C18D101

**RE: Drainage Resubmittal
Silver Oak Subdivision- (C18D101)
Albuquerque, New Mexico**

RE: Silver Oak Estates | Grading and Drainage Plan | Stamp 10-21-15 (File: C18D101)

SILVER OAK SUBDIVISION
Albuquerque, New Mexico

ENGINEER'S SEAL		SILVEROAK ESTATES GRADING AND DRAINAGE PLAN	 <i>Rio Grande</i> <i>Engineering</i> 1700 CENTRAL AVENUE SUITE 201 ALBUQUERQUE, NM 87104 PHONE (505) 275-1000	SHEET # 3	JOB # 215525
				DRAWN BY MCM/ DATE 12-11-15 PENDING - LAYOUT - 12-15-15	
DANAO SOLE P.E. #14322

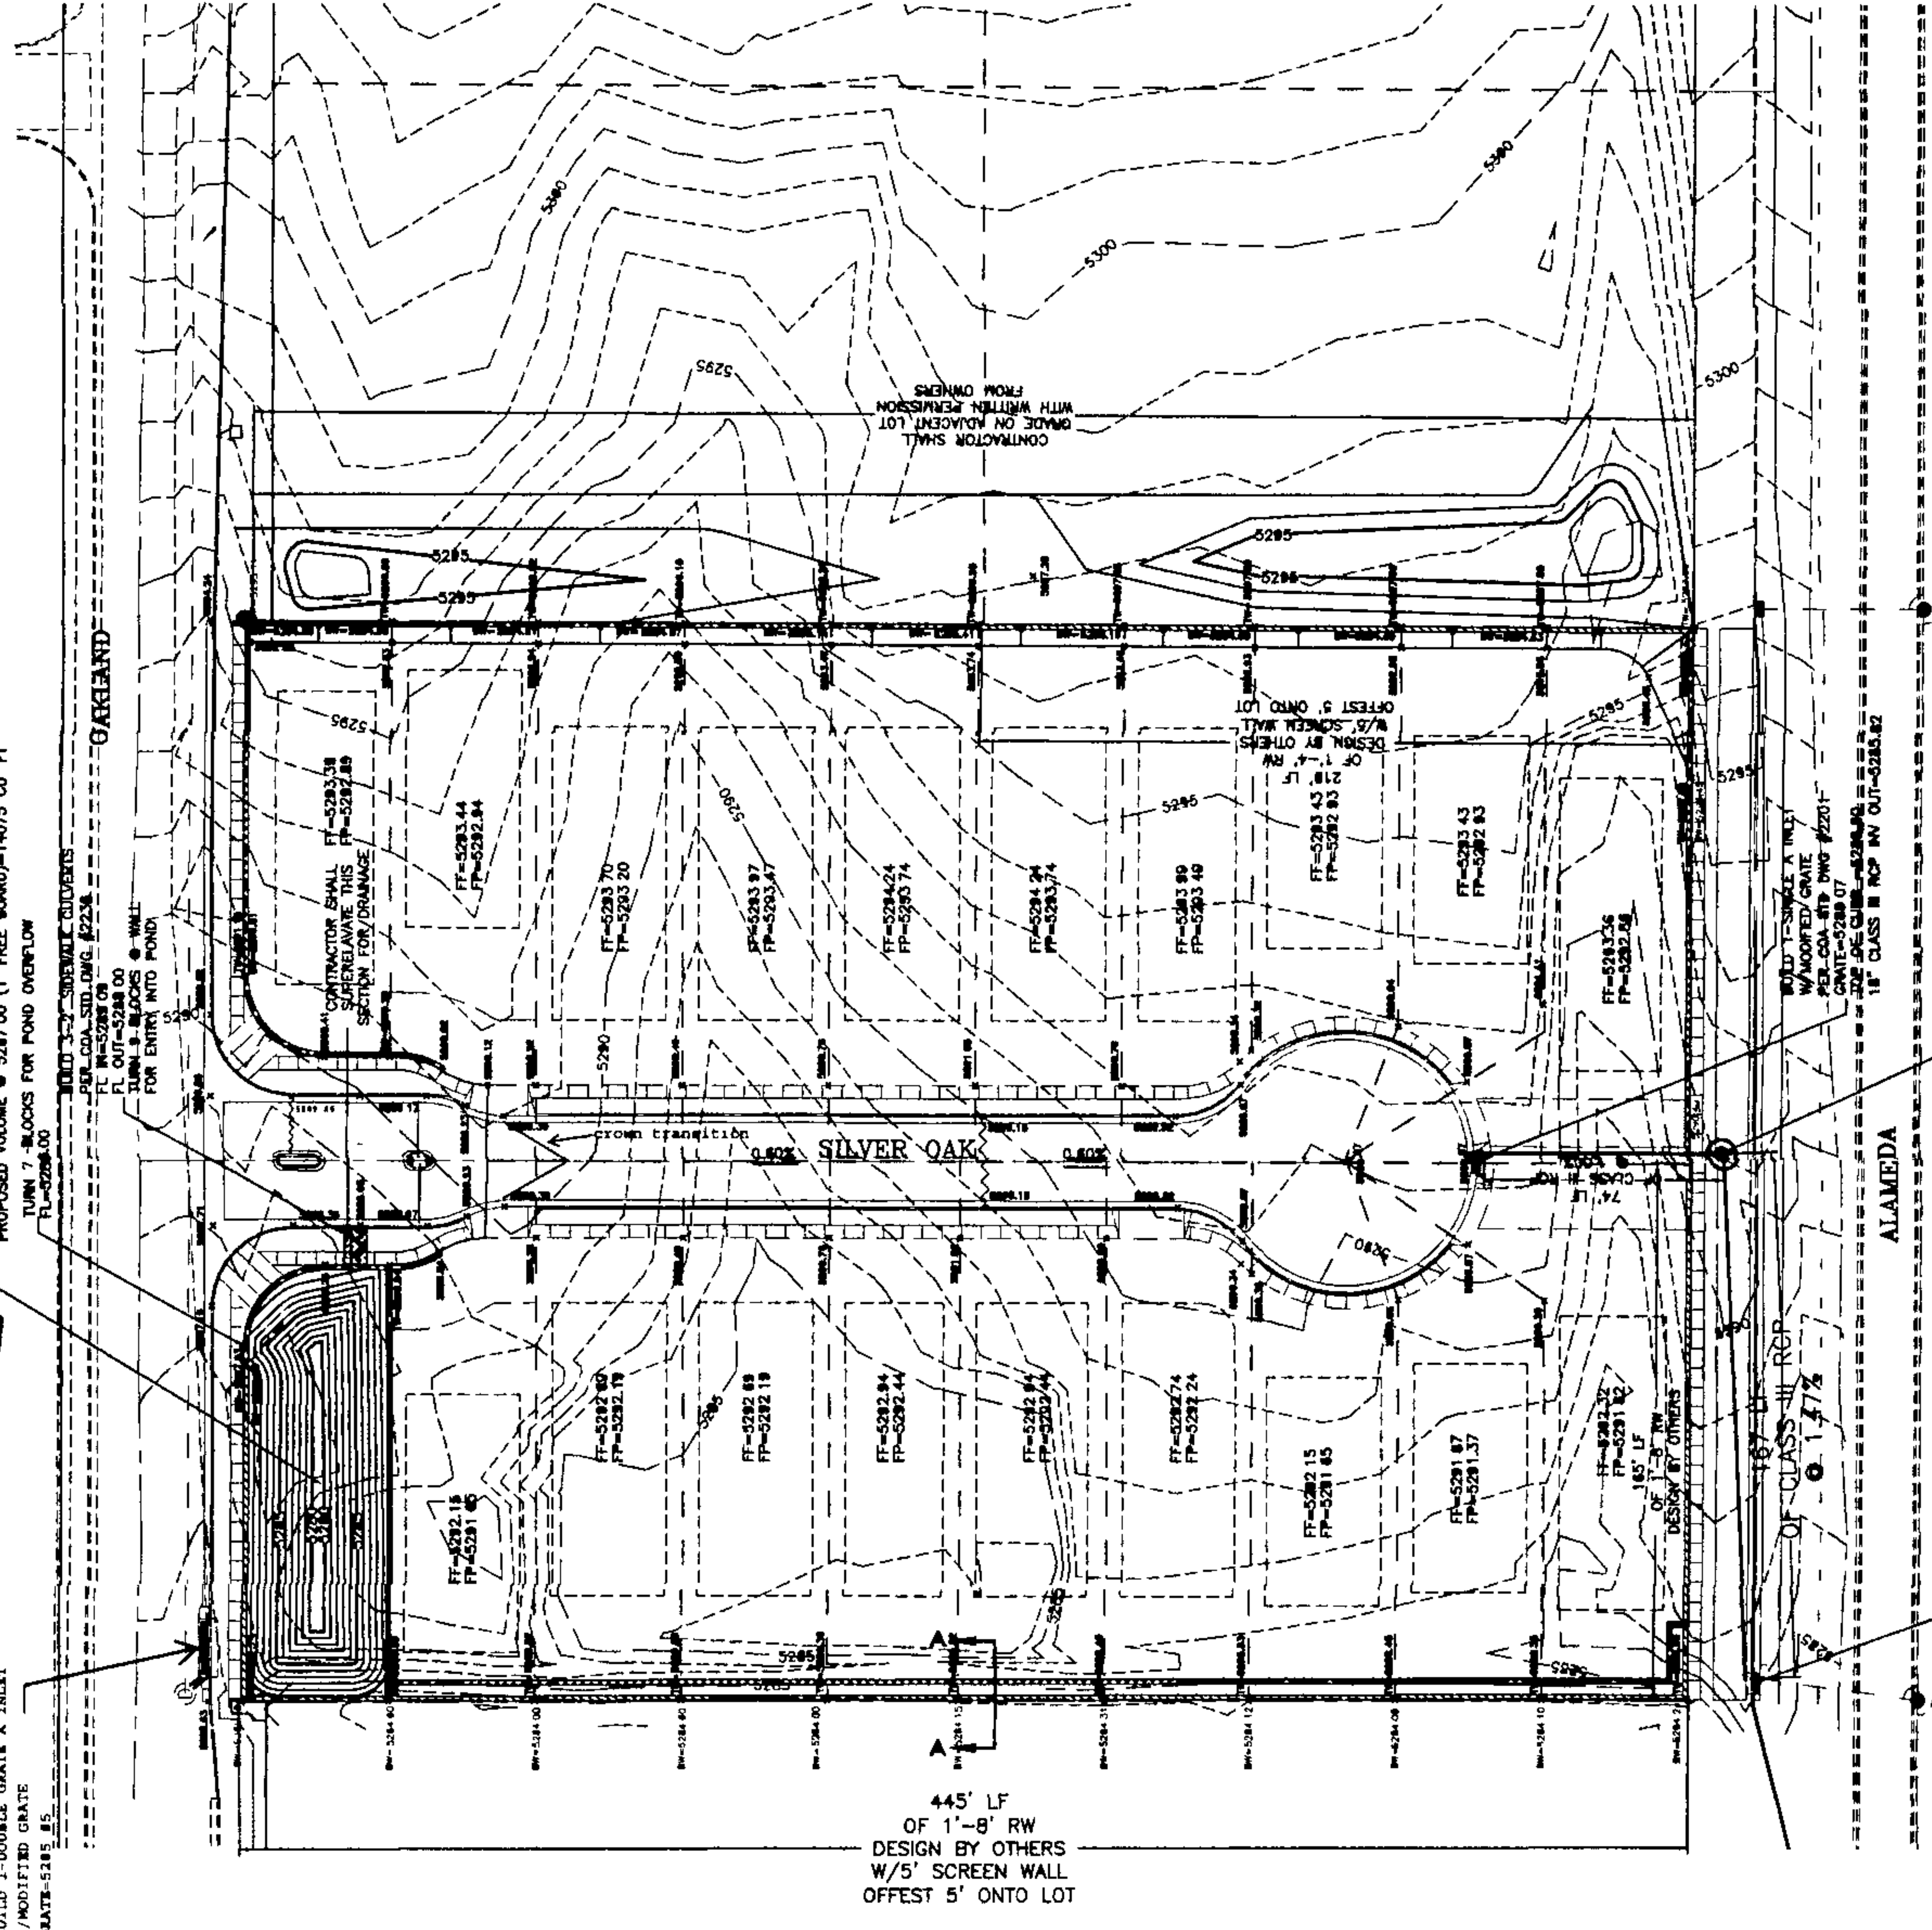
1. Clarify the easement dimensions between the cul-de-sac and Alameda Blvd. The Utility Plan shows a different layout than the Site/Grading Plan.
2. The inlet at the end of the cul-de-sac bulb appears to conflict with the intent to have an access easement to the southernmost lots.

3. At the entrance, there is a low spot on the northbound side curb and gutter; it appears that the intent is to convey flows west into the temporary pond. The plan should clarify to the Contractor that the crown of the road is to be warped so as not to create a sump.

4. The inlets on Oakland and Alameda should have build notes
 - a. The inlet on Alameda is referenced as a single grate Type D inlet to capture flows at the flowline of the roadside swale, but shown differently on the plan. Furthermore, this inlet and pipe needs to be planned with the future expanded section of Alameda Blvd in mind.

5. Show the emergency spillway for the pond as referenced in the drainage report.
6. Call out the wall opening that will be needed to convey flows into the pond.

7. Show elevation points at the rear lots that show the intent to install rear lot ponds.
 - a. The rear and front yard ponds and typical lot layout showing the first flush ponds should also be shown on the landscaping sheets, since it appears that the fine grading of those facilities might be completed with the installation of graveling and plantings, not with the grading of the lots.

1. Clarify easement dimensions between cul-de-sac and Alameda
We have corrected the preliminary plat. There are three easements, one is a 20' private drainage easement on the east, a 20' public water line is on the west and a 10' private access easement straddles the two. The access easement is for pedestrian connectivity to alameda. It also serves as an emergency overflow.

2. The inlet at the cul-de-sac conflicts with access to southern lots
We have reduced the inlet to a single A, the inlet is in sump and has double the capacity. This inlet calculation has been included. We have shown the driveways to confirm the geometry

3. Correct low spot at entrance
We have provided a transition for super elevated roadway to provide water block to Oakland as well as allowing onsite water to be captured by the temporary pond. The detailed road profiles and median flow lines at DRC will assure proper flow. We have eliminated the low spot.

4. Inlets in Oakland and Alameda shall have build notes. The plans and report need to be consistent. The location needs to account for Alameda ultimate section
We have added the build notes and corrected plan to conform to the report. The proposed inlet in Alameda is being placed where an existing stub was constructed. The inlet is being placed at the ultimate curb location.

5. Show emergency overflow
We have modified the contours to identify the overflow. We have labeled the turned blocks at the wall. Since this is an emergency overflow for a temporary pond we are not proposing culverts. We have included the capacity calculation for each turned block. The pond inflow is 6.89 cfs and each turned block has a capacity of 1.04.

6. Call out wall opening
We have placed build notes for the wall openings.
7. Show elevation points at rear yard pond, landscape plan should show front yard pond
We have added a typical section for the rear yard and front yard ponds. To add points to grading plan will make the document illegible. We have added pond to the landscape plans

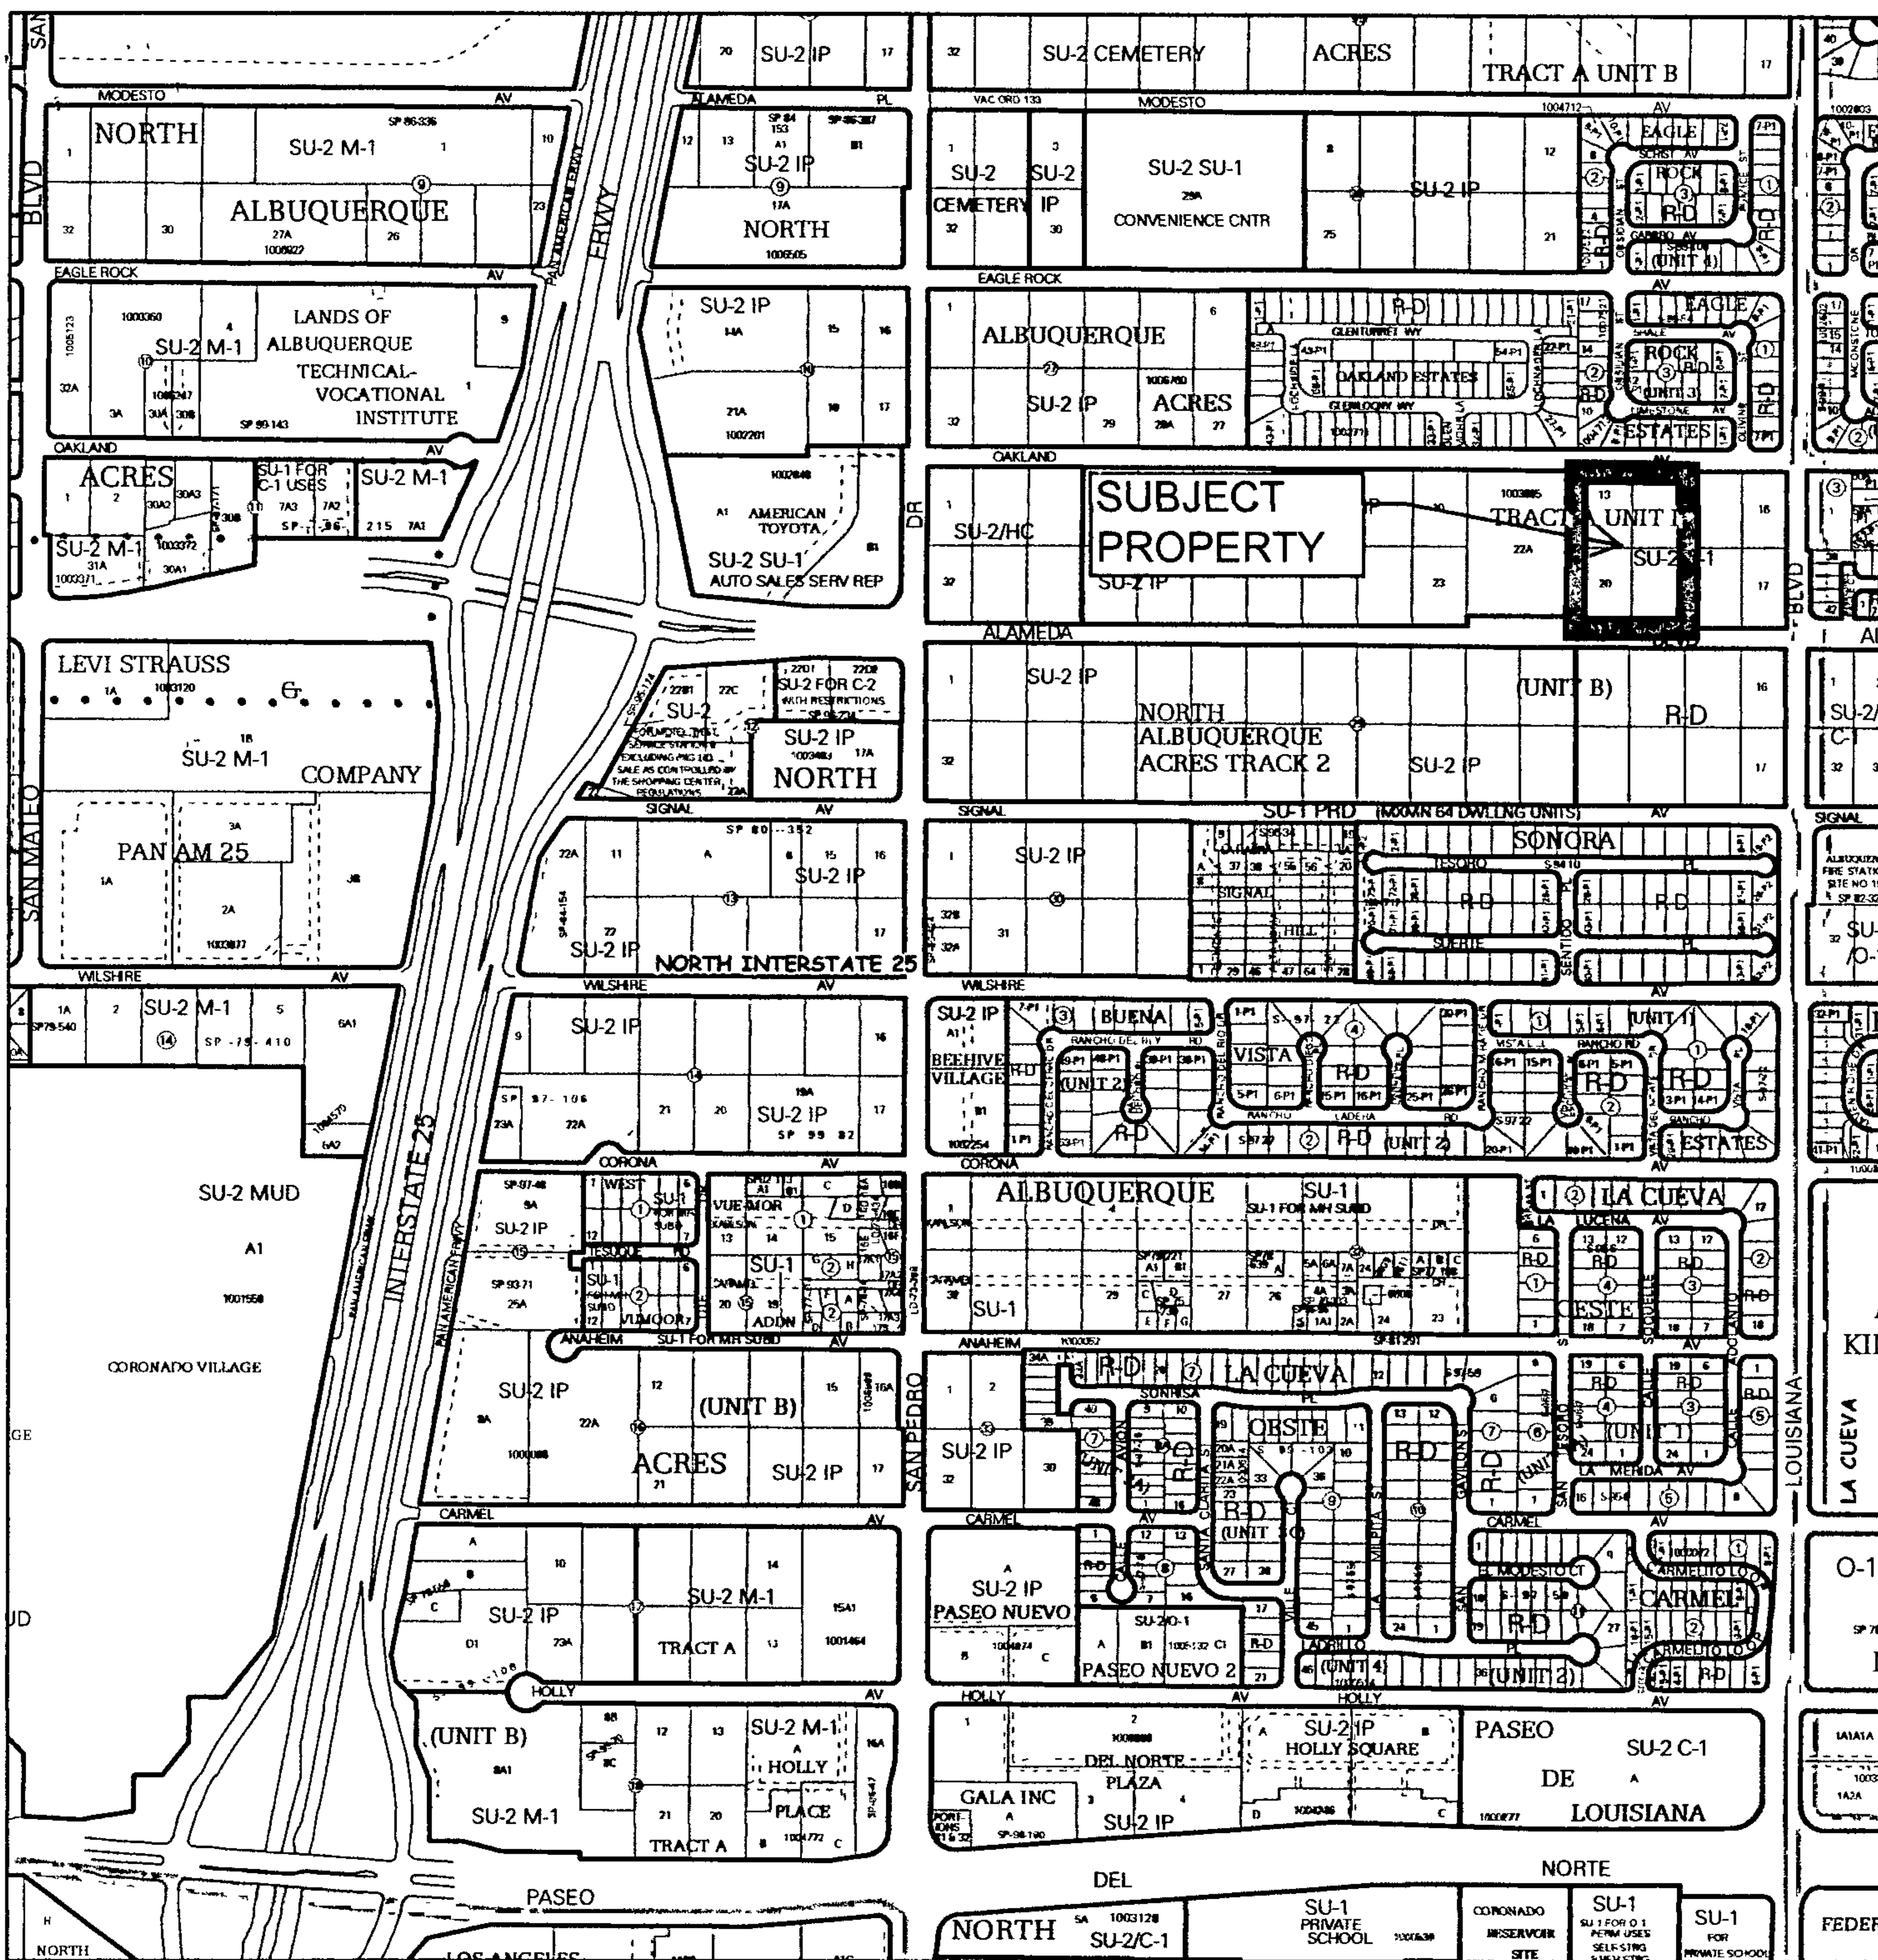
Where? There's only a type A shown on Alameda and a manhole suggested at the interim junction

~~Wouldn't it be better to install the pipe where it needs to be in the future?~~

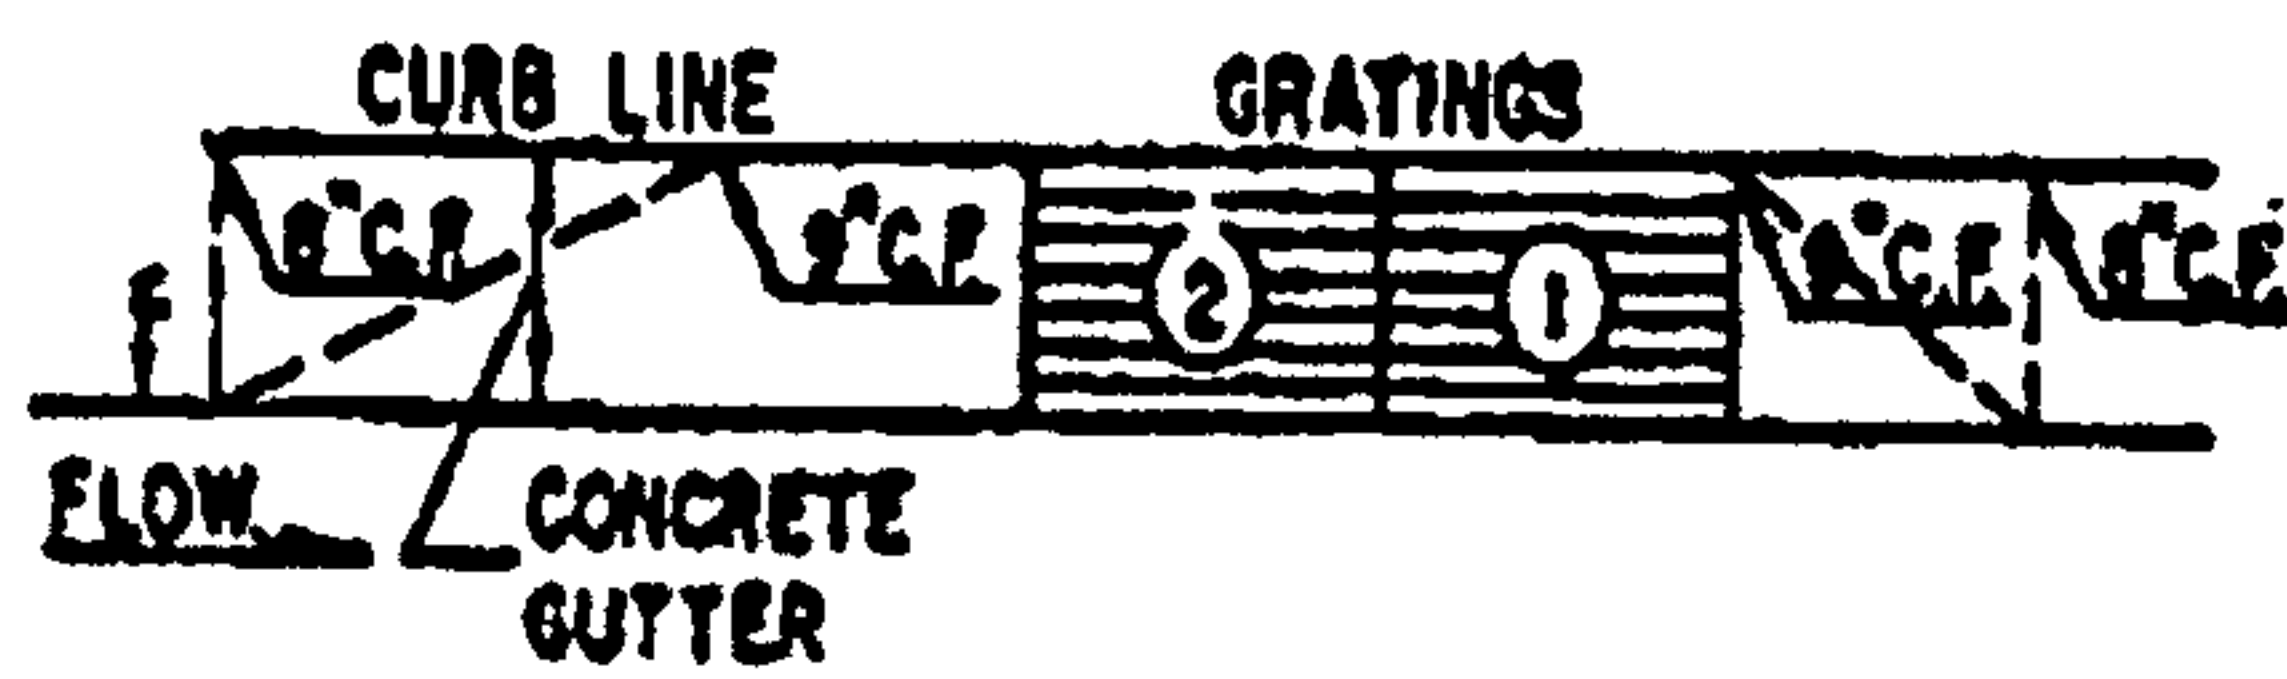
In plan dated 12-11-15
 only ~~1~~ ² grates a single
 grate is shown,
 so $\frac{34.9}{2} \approx$ new capacity
 $= 17.45$ cfs cap
 Q for Basin B = 7.09
 50% clogging = $(7.09)^2 =$
 14.18 cfs needed
 ✓
